**CITY OF HAYWARD**  
**AGENDA REPORT**

**SUBJECT:** Zone Change No. PL-2003-0533 & Vesting Tentative Tract Map 7470/PL-2003-0534 – Trumark Companies (Applicant)/ The Domoto Family Partners LP (Owner) – Request to Change the Zoning From Agricultural (A) District to Planned Development (PD) District and Subdivide 5 Acres to Build 46 Homes - The Project Location Is 26521 Whitman Street

**CITY OF HAYWARD  
PLANNING DIVISION  
ZONE CHANGE APPROVAL**  
*(Revisions by Planning Commission in italics and underlined)*  
**(Revisions by staff in bold)**

**ZONE CHANGE APPLICATION NO. PL-2003-0533:** Chris Davenport for Trumark Companies (Applicant)/ The Domoto Family Partners LP (Owner) – Request to Change the Zoning From an Agricultural (A) District to a Planned Development (PD) District and Subdivide 5 Acres to Build 46 Homes

# Partial Alternate Site Plan

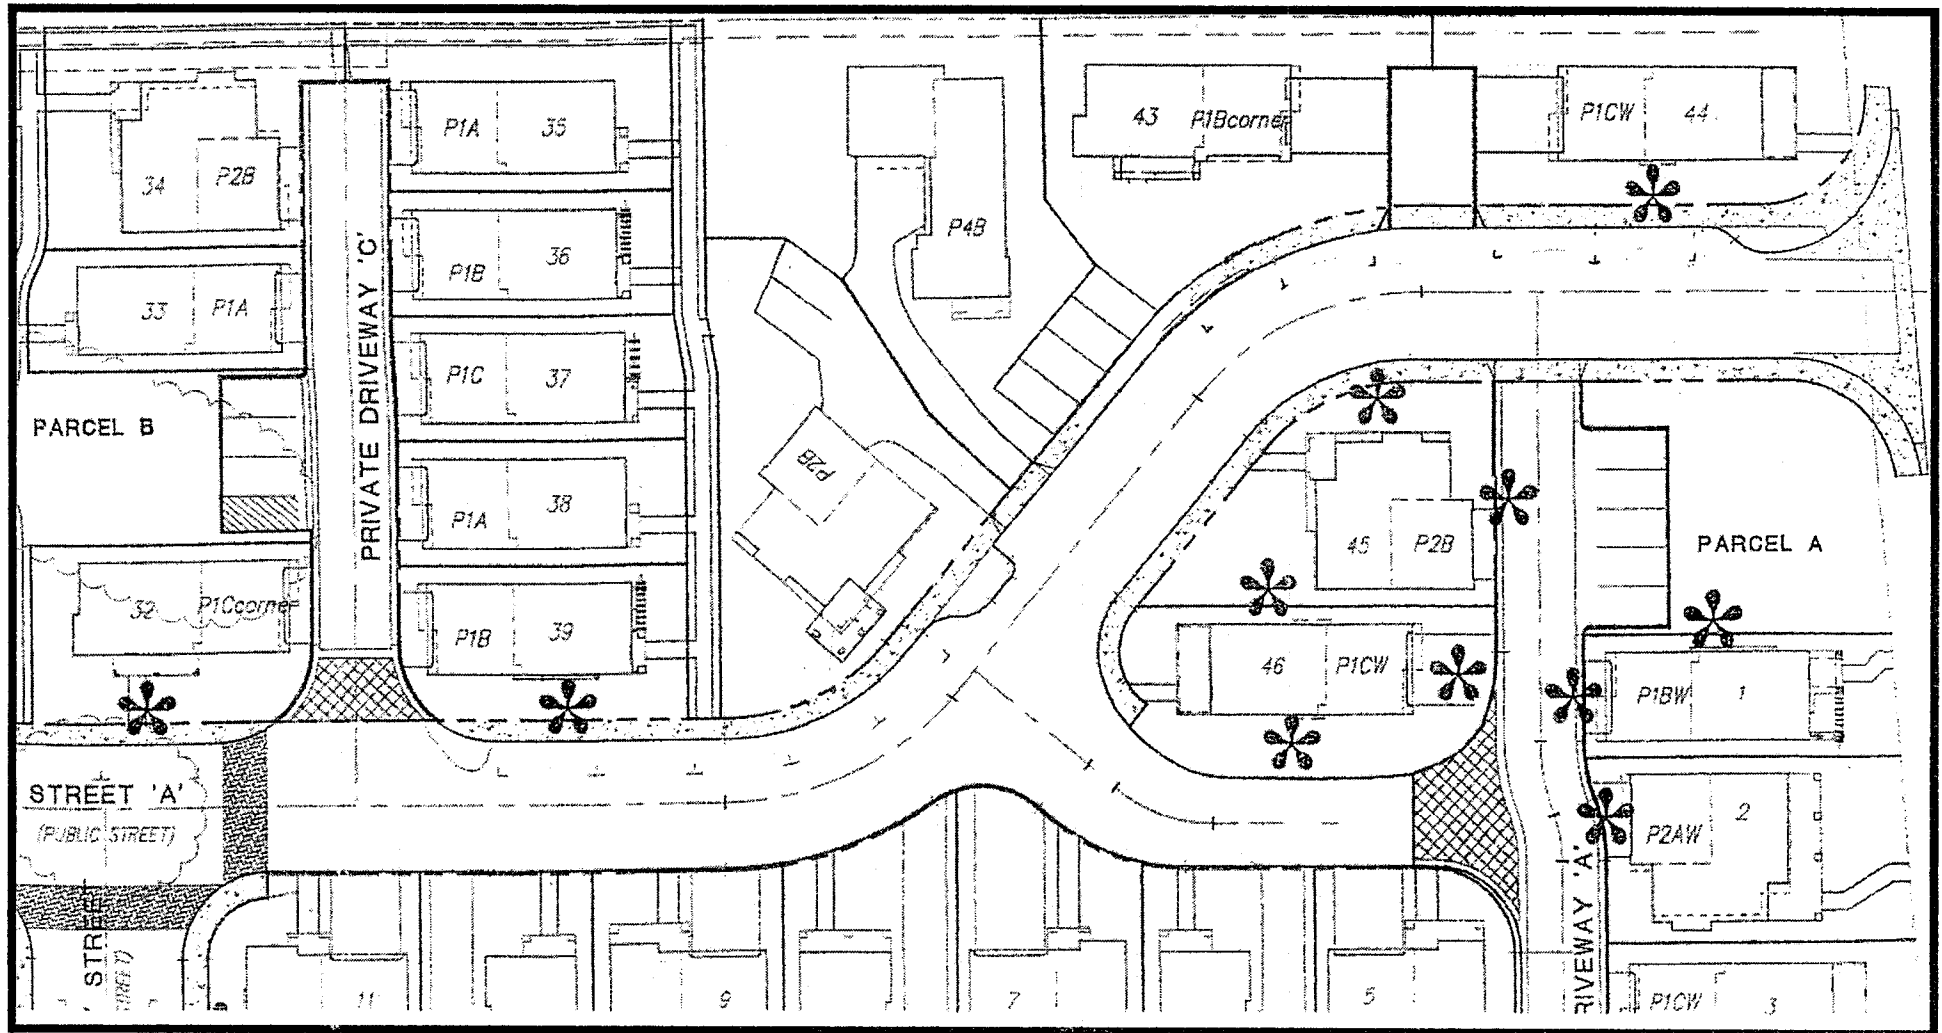
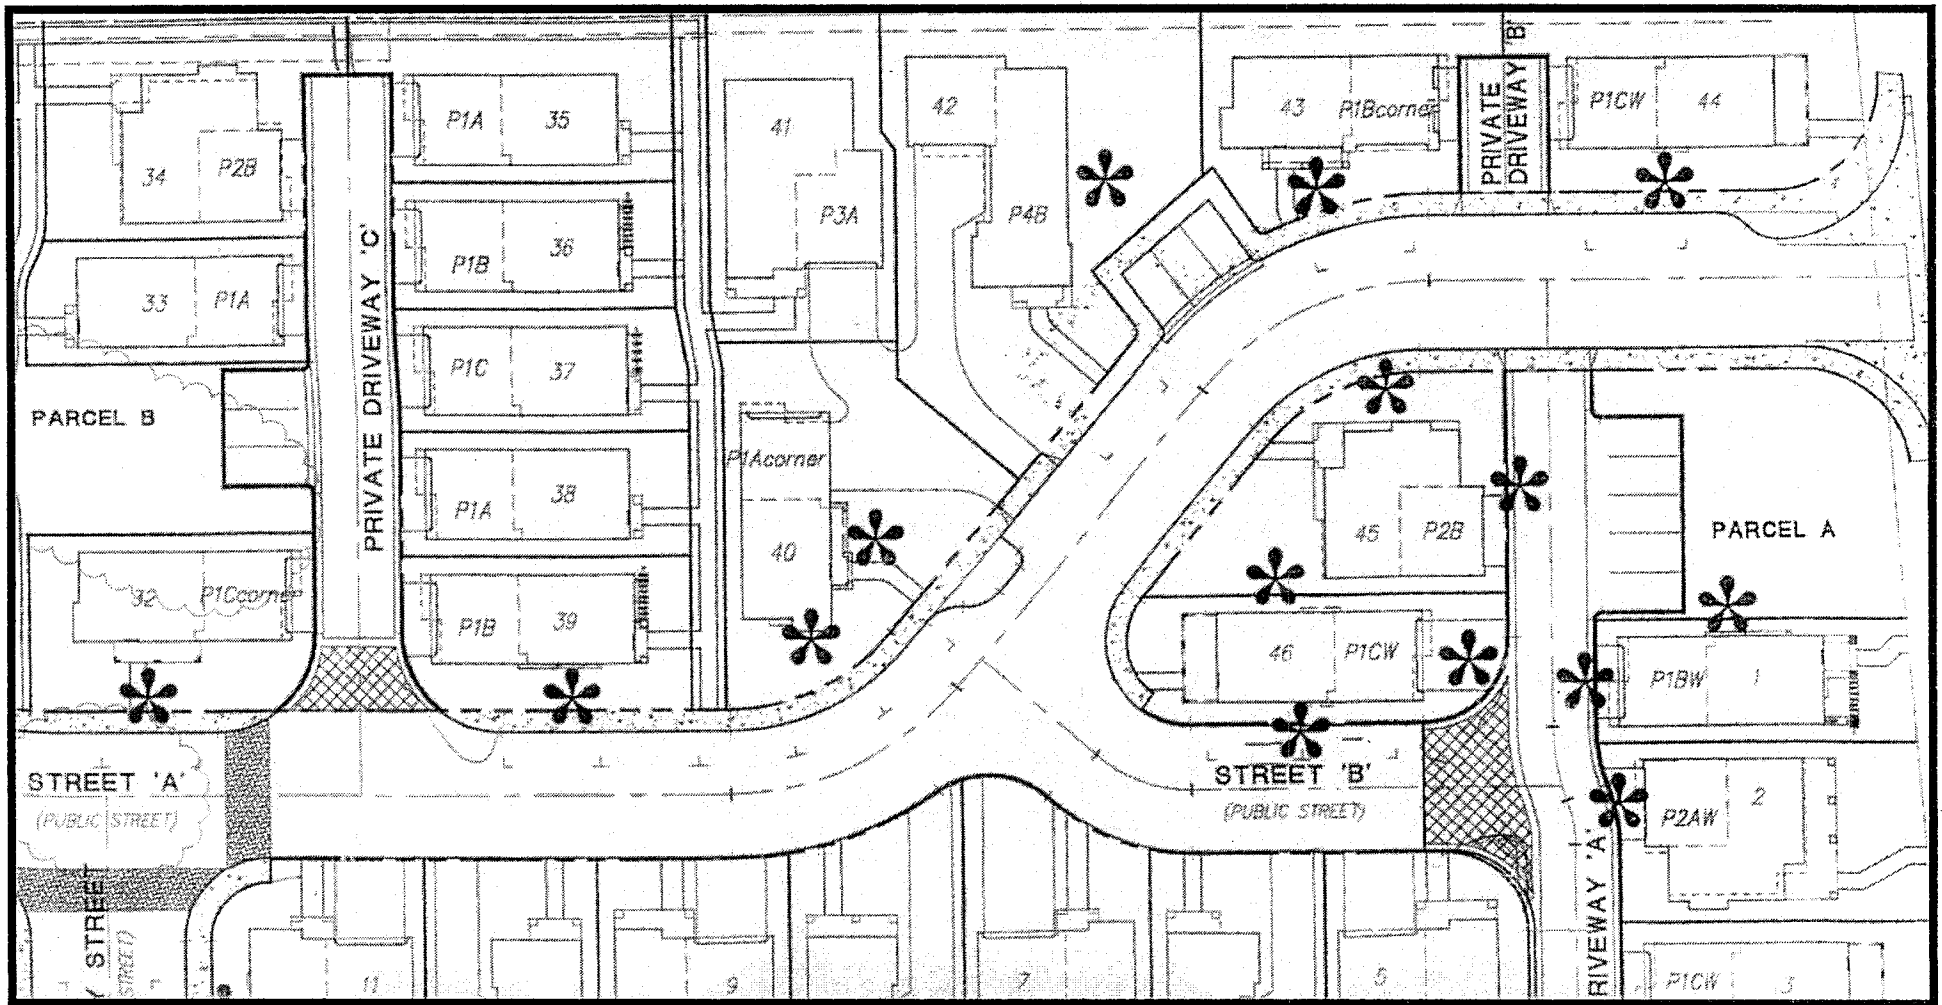
Staff recommends that Lot 41 be eliminated from the site plan because the house proposed for the lot, due to its orientation to the street and the two neighboring houses, would create a view primarily of garages at the entry to the project. Three homes would also share a single driveway, causing potential conflicts between neighbors. Its elimination would also provide for expanded yard areas and a greater parking ratio. The Planning Commission, however, recommended that the house on Lot 41 be retained. Staff continues to recommend elimination of the house on Lot 41 and has prepared a conceptual alternate site plan (see Exhibit A) illustrating the benefits cited above. The plan shows that all houses could have direct, convenient pedestrian access from the sidewalk to the entry. The total number of parking spaces could be increased from 178 to 182, increasing the parking ratio from 3.87 spaces per unit to 4.04 spaces per unit. For comparison purposes, Brighton Village at Stratford and Industrial Boulevard was approved with four parking spaces per unit. The plan would also create larger yards, private parking on Lots 43 and 44, and room for larger porches. Finally, the 'Street B' could be narrowed to a private drive, enlarging the yard for Lot 46. Two on-street parking spaces proposed adjacent to Lot 46 could be relocated to 'Street A' and an enlarged parking bay.

Planning Commissioner Bogue asked for further clarification on how the elimination of Lot #41 could allow additional yardage and parking as there is only one curb-cut. Staff responded that the two homes could be re-oriented to have separate driveways to the main public street and enlarge the parking bay.

- k) Sheet A-8 shall be revised to show that railings will have a vertical wood design.
- l) **The site plan shall be revised to eliminate the house on Lot 41. Public Street B shall be made a private driveway and Lots 45 and 46 made larger. Lots 40 and 45 shall have private yards.**
